# Service bulletin concerning fatigued manifold block bolts

DOCUMENT NUMBER 1035207

Document Summary
Bolt fatigue on cylinder manifolds

Figure 1 cylinder showing the affected bolts

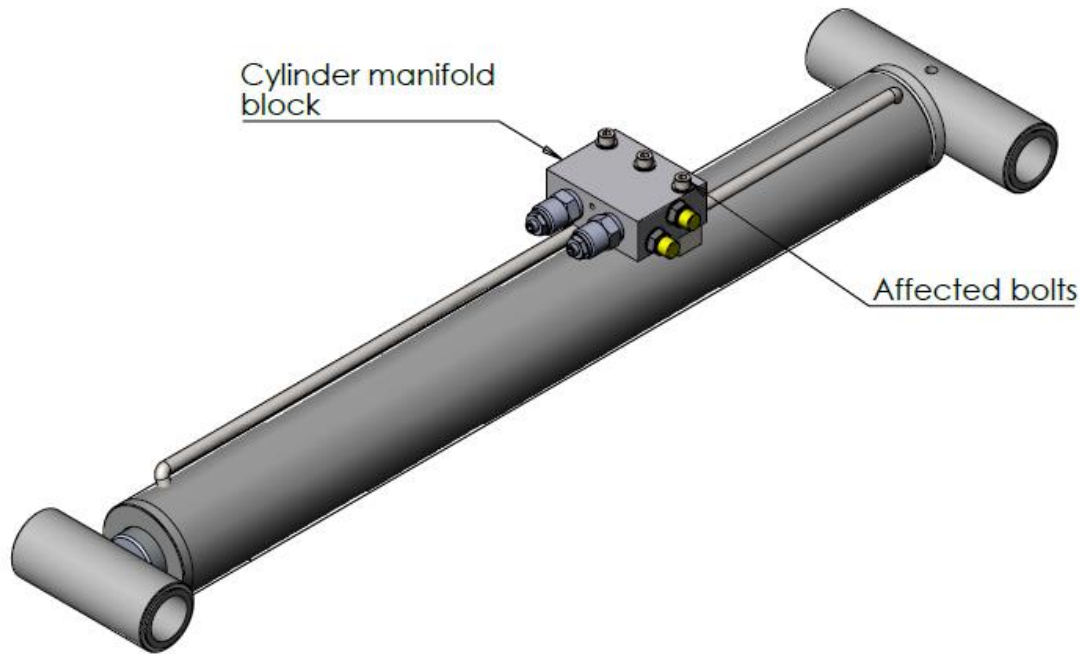
Two cases have just been reported of fatigue occurring on the bolts which hold the manifold blocks onto the jib (upper boom) cylinders. As shown in Figure 1, below:

In both cases one of the bolts had fatigued and the bolt head was lost. There has been no immediate risk of health and safety incidents, as each manifold is secured with three bolts, and the remaining bolts in both cases appeared to be in good condition. Nevertheless, any deterioration in the connection between the manifold block and the cylinder is serious, as total failure would lead to the uncontrolled descent of the booms.

All V, VZ, VX and VZX systems which have been in service since 2016, must be checked, this means any system with a serial number greater than 13417.

If any damaged bolts are found, the owner / operator must remove the platform from service immediately, and contact Aldercote, to arrange a repair.

If all bolts are found to be in good condition, the system can continue in use, but the bolts should be checked as part of the routine daily checks.

The bolts on the jib, main boom and lower boom cylinders should be replaced at the next LOLER inspection. Aldercote will provide the necessary bolts free of charge. Please contact the service manager to request the bolts required for your system.

When fitted, the bolts must be torqued to no more than 10Nm. A medium strength thread locking adhesive should be used.

Figure 2 Cylinders affected by the possible defect

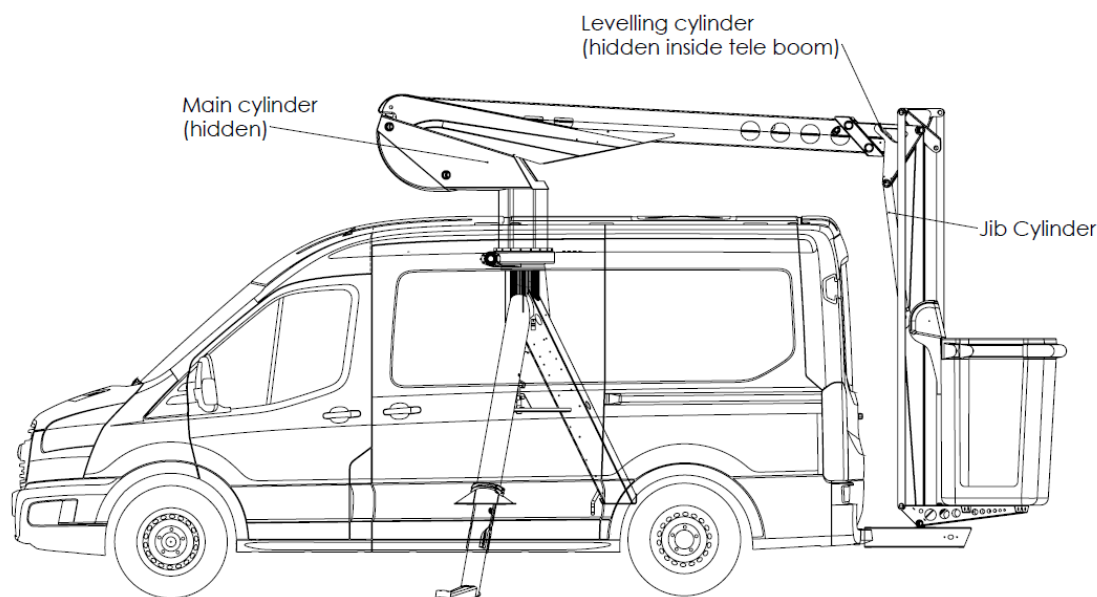
Manifolds are fitted in this way to the main boom cylinder, jib cylinder, levelling cylinder (VZ, and VZX only) and the lower boom cylinder (VZX and VX only) as illustrated below.
